# Housing Authority of the City of Pittsburgh

**Phase II Roof Replacements at the Northview Heights Family  
Community  
IFB#600-45-12**

**ADDENDUM NO. 2**

28 Oct 2012  
 REV 20 NOV 2012  
 modifies  
 sheet:  
 STORMWATER PLAN  
 Scale: As Noted

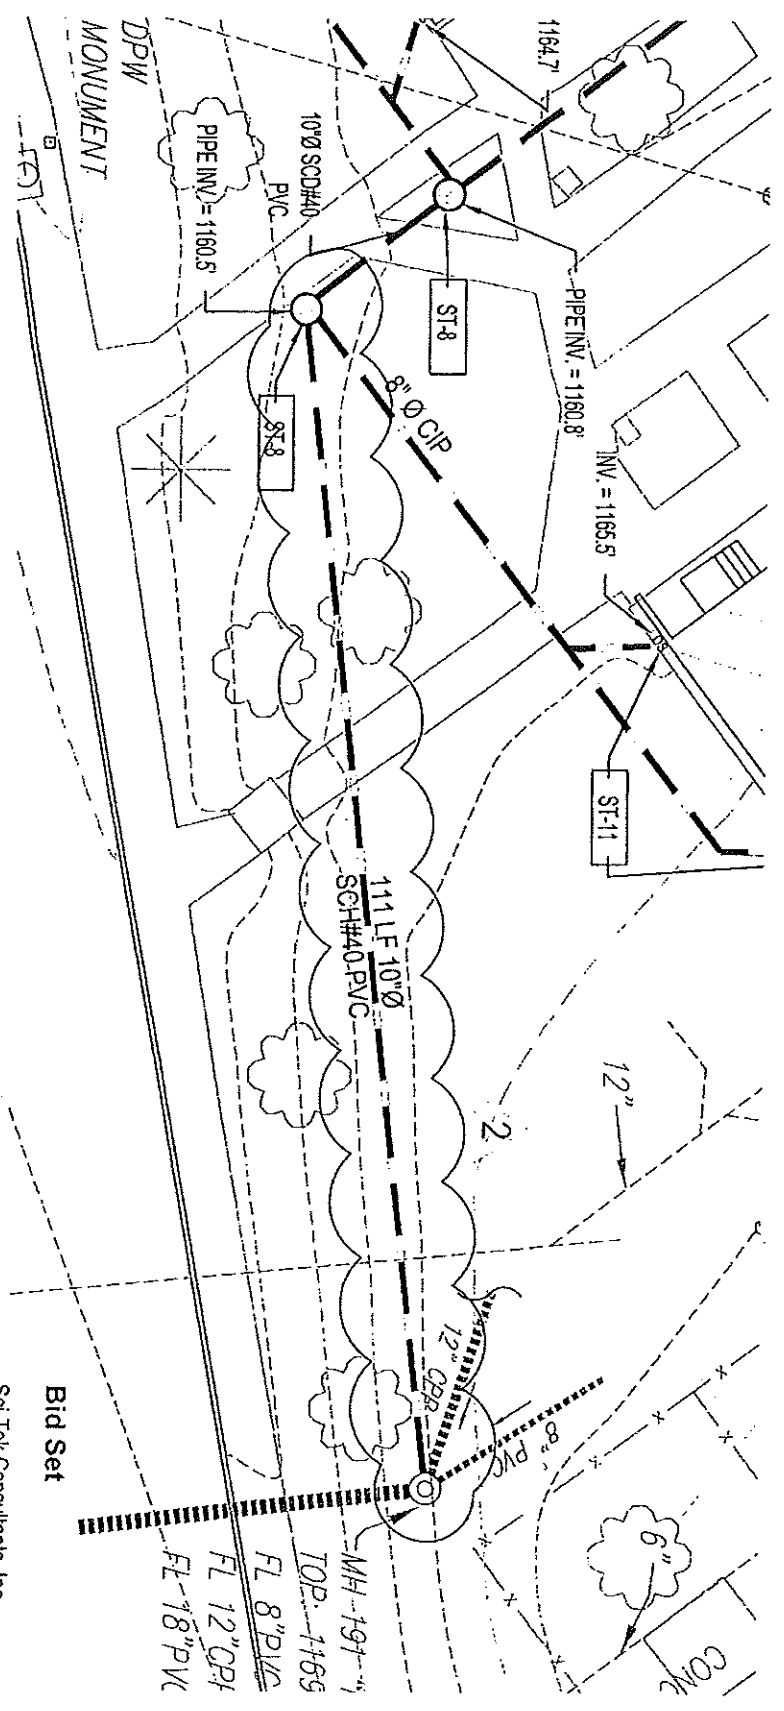
**Item 2:** Replace portion of drawing 2/C1.1 with the attached revised drawing vignette C1.1 dated 20 November 2012.
